PROJECT	VARIATION 1 TO THE PROPOSED DISTRICT PLAN: REZONING SUBMISSIONS
SUBJECT	REVIEW OF V1-0068 TRANSPORT REBUTTAL EVIDENCE
TO	VICKI BARKER; JUSTINE ASHLEY
FROM	MAT COLLINS
DATE	13 JUNE 2023

SUMMARY OF MY PEER REVIEW

1 V1-0068: ALLENDALE LANE, LINCOLN, MANMEET SINGH

Figure 1: Indicative frontage that is required to support V1-0068

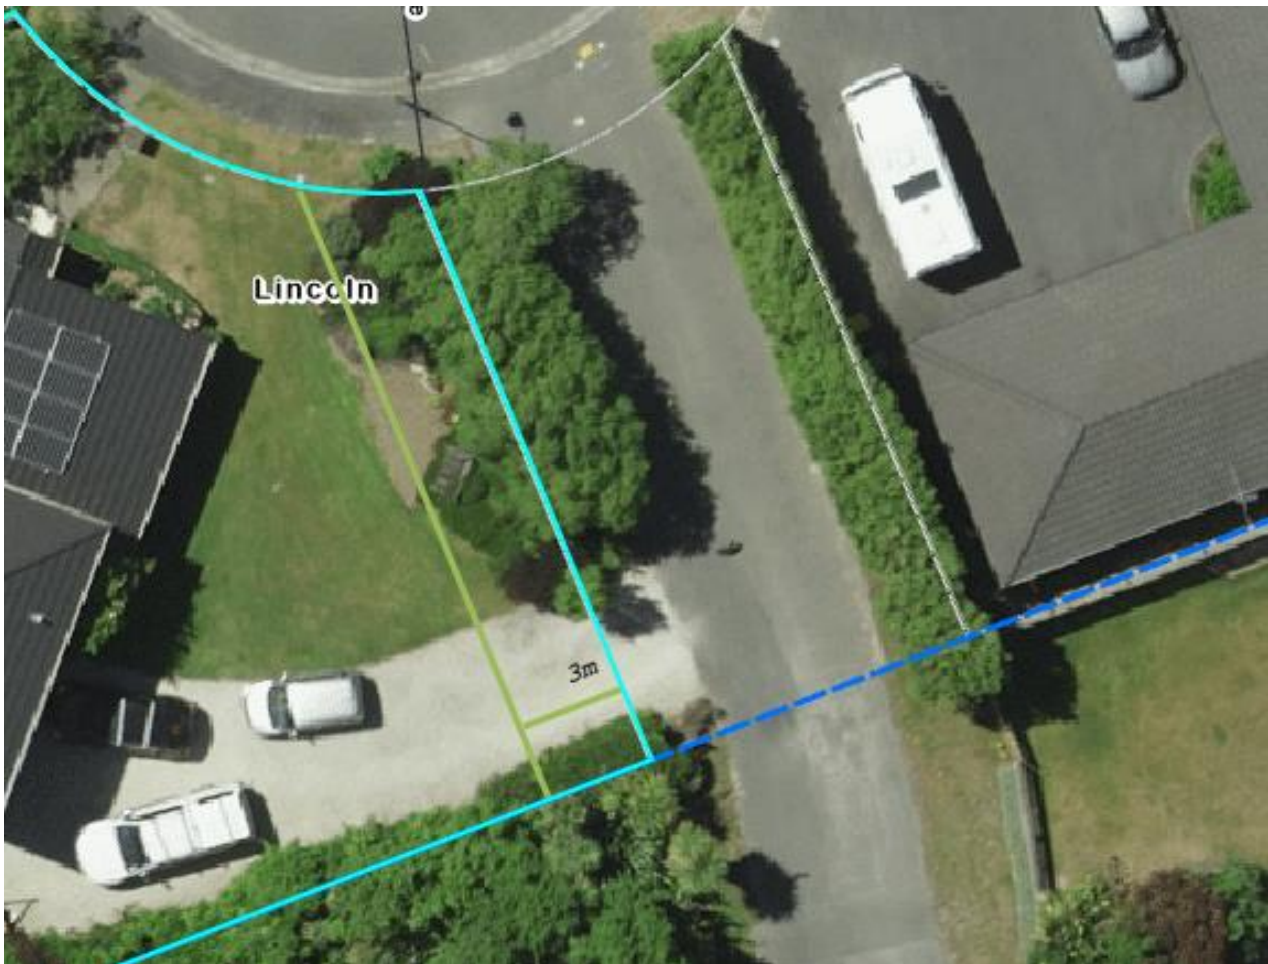
I am concerned that a proposed 10m wide legal road will impact users safe, efficient and convenient access and movement to and from the V1-0068 site.

A 13m wide corridor could be provided by the submitter entering into a willing buyer/willing seller agreement with the owner of 10 Allendale Lane, to acquire 3m of frontage and vest this to Council. I have shown this indicatively in Figure 1. Unless the submitter widens the proposed 10m wide Allendale Road extension to a minimum of a 13m wide corridor, I recommend that the rezoning request be declined. For clarity, I consider that all other roads within the site should comply with all aspects of the Transport Chapter, and that a narrowed width of 13m would only be acceptable between 5 Allendale Lane and 10 Allendale Lane, as shown in Figure 1.

Figure 2: Proposed Development Area, recommended amendments

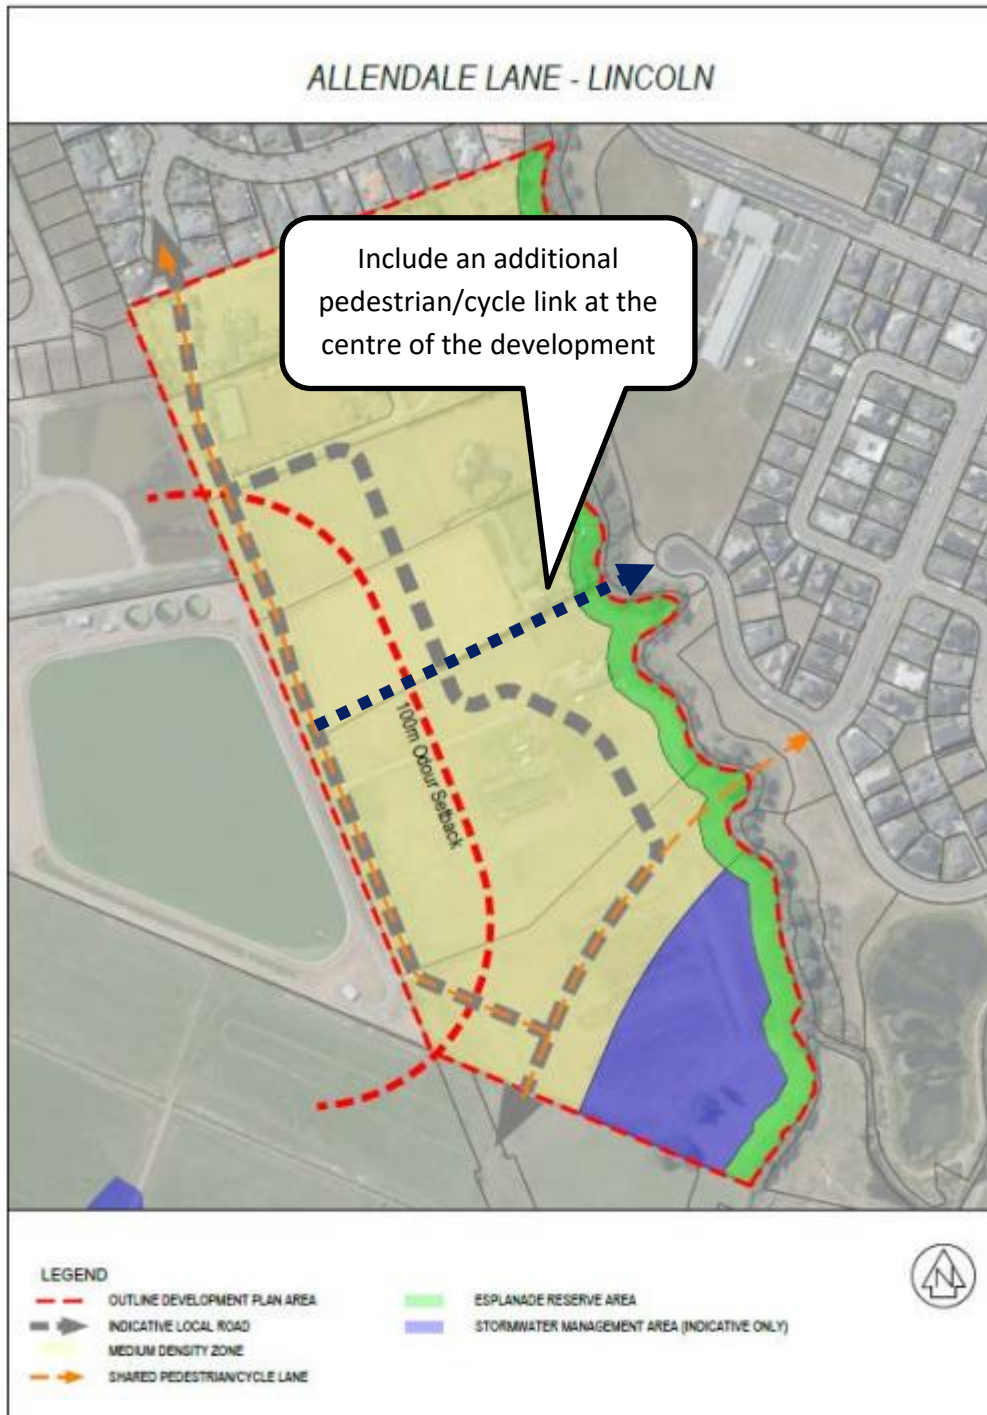
- ◆ The ODP is updated to include a walking and cycling link to Jimmy Adams Terrace in the centre of the ODP area, and that the developer is required to form this link including a bridge over the Liffey stream. This helps address the otherwise limited connectivity for the site, provides pedestrians with an alternative route to avoid the 10m section of Allendale Lane extension, and assists to reduce the total vehicle kilometres travelled (VKT) that will otherwise be generated by the development.

- ◆ The ODP narrative includes a discussion of Council having discretion to close the 10m section of Allendale Lane extension to general traffic, if an alternative roading link is provided (for example the indicative roading connection to PC69 shown in the ODP). This clearly signals that Council may

- ◆ That the proposed roading link to PC69 is retained within the ODP plan and ODP narrative.
